Response to the reviews

Reply to the comments of referee#1

The manuscript: Updating Thermal Head of Recoverable Autonomous Sonde (RECAS) for Better Drilling Performance in Qilin Subglacial Lake Exploration submitted by Li et al., reports on updates to an existing drilling instrument. The manuscript is well-written and generally easy to follow, also for a non-expert like me in this niche area. The English language is generally good, with only a few odd phrasings (that are still easy to understand).

Figure S1 The structure of the filter

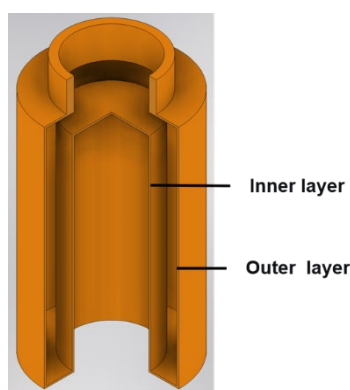
Line 110: The manuscript would benefit from an improved description of the filters used to remove dust, i.e., what materials are used. Further is also not clear to me if the dust can risk clogging the filters or does the design make dust move into the internal cavity? The text states that dust is collected in this internal cavity. How big is this cavity and is there a risk of overfilling it during deep drilling? Please clarify this in the manuscript.

Nevertheless, a real risk of filter clogging exists. To reduce the likelihood of blockage, the contact area between the filter and water was enlarged through a double-layer design. As illustrated in Fig. S1, the two-layer stainless-steel wire screen provides approximately twice the contact area of a single layer. A total of five filters are employed.

“Nevertheless, a real risk of filter clogging does exist. To mitigate this, the contact area between the filter and the water was increased through a double-layer design. The two-layer screen provides approximately twice the contact area of a single layer.”

Figure S3. Photograph of the water cavity: (a) without pebbles; (b) with pebbles. (In the revised manuscript, Figure S2 has been added as Figure 15.)

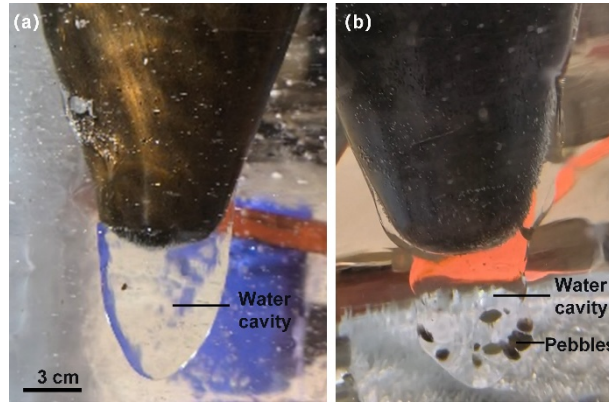
(2) In the case of rock inclusions (Section 4.4), it must be expected that ice above the intended lake will have debris layers with many rocks in close proximity (many more than 5). To begin to evaluate the significance of the results with so few rocks, the first question is whether melt head penetration at the specified jetting rate, and the mechanism the authors suggest (melting of a cavity large enough for the rocks to move up the sidewall of the probe as it descends), are in fact repeatable, or whether other results are sometimes obtained – the authors presently seem to have presented results so far only from a single trial. If the current results are repeatable, it would then be essential to begin to explore the relationship between successful penetration and (1) jetting rate; (2) mass fraction of rock embedded in an ice layer; and (3) rock size. I would urge the authors to add data along these lines to the paper.

As shown in Figure S3(a), a conical water cavity formed during drilling in clear ice, with both its depth and maximum diameter approximately 60 mm. After the pebbles were added, the cavity still existed, and all the pebbles settled at its bottom (Figure S3(b)). In this case, the cavity had almost the same dimensions as the one without pebbles.

“*As shown in Figure 15(a), a conical water cavity formed during drilling in clear ice, with both its depth and maximum diameter approximately 60 mm. After the pebbles were added, the cavity still existed, and all the pebbles settled at its bottom (Figure 15(b)). In this case, the cavity had almost the same dimensions as the one without pebbles. Clearly, the formation of a water cavity is the main reason for eliminating the influence of pebbles on ice drilling*”.
